## **Ascent Church**

Final Drainage Report

PCD File No: PPR265

April 2026

# ASCENT CHURCH PCM APPLICABILITY MAP

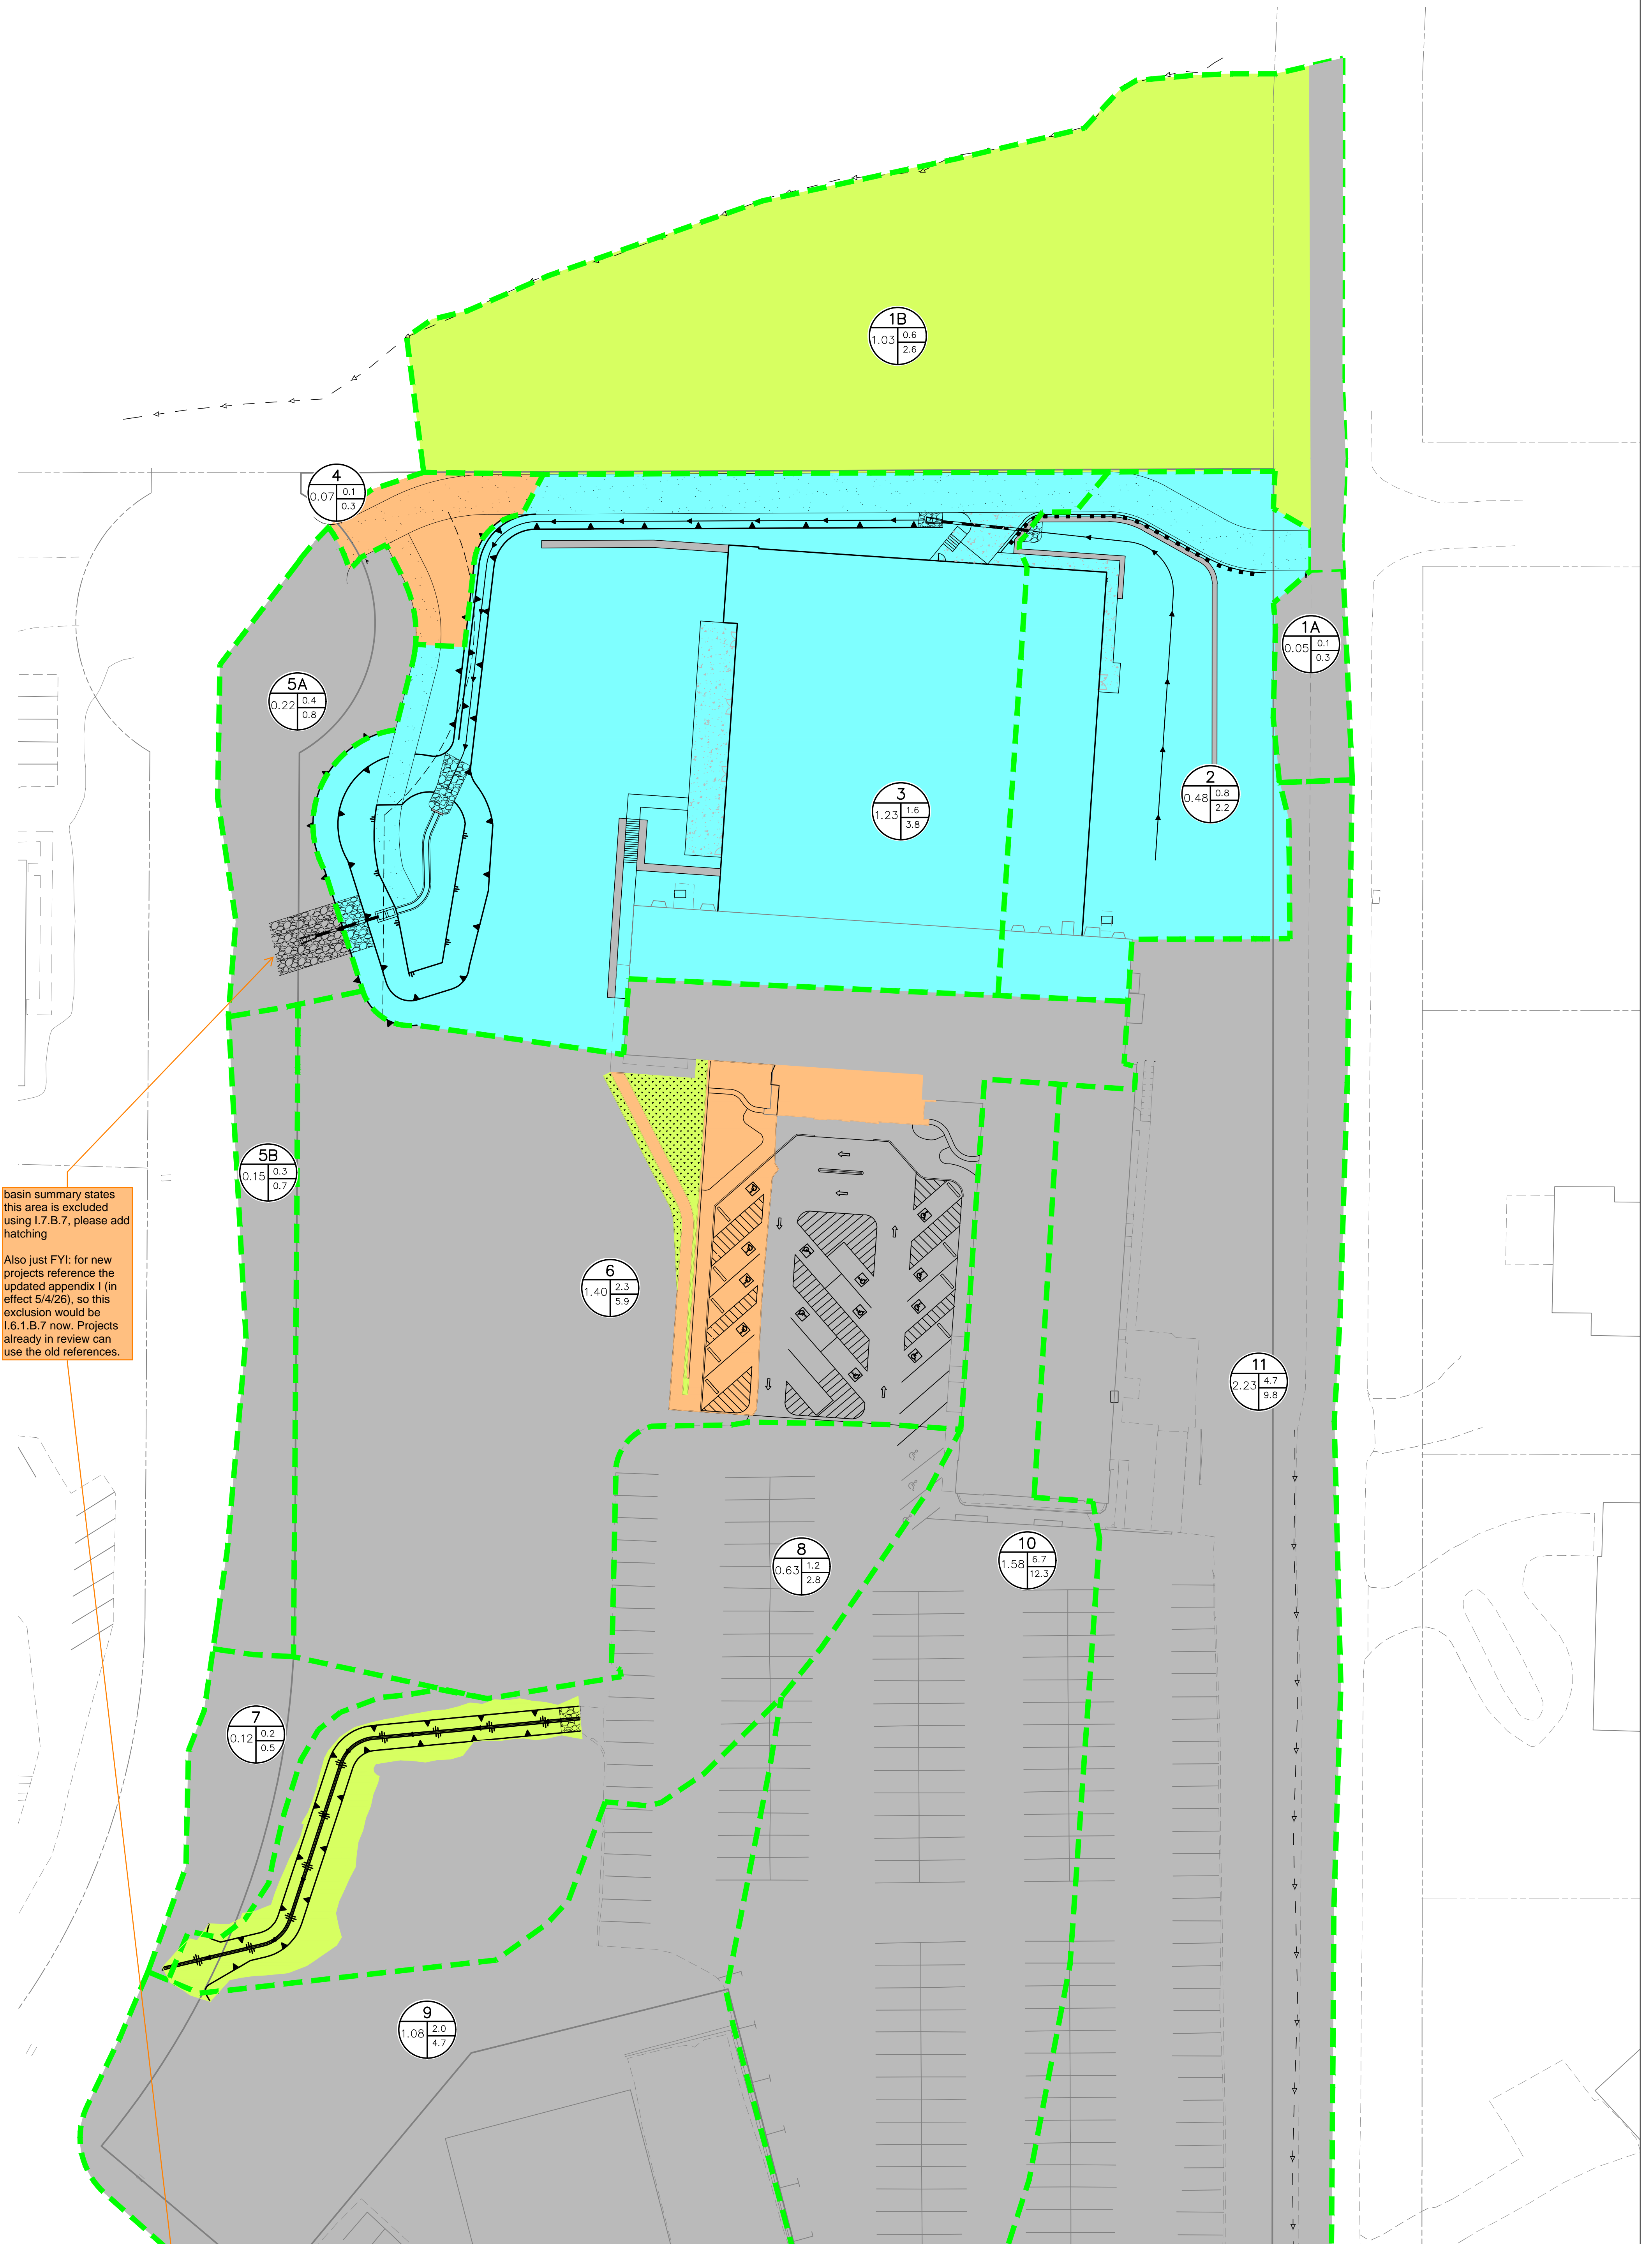
basin summary states this area is excluded using I.7.B.7, please add hatching

Also just FYI: for new projects reference the updated appendix I (in effect 5/4/26), so this exclusion would be I.6.1.B.7 now. Projects already in review can use the old references.
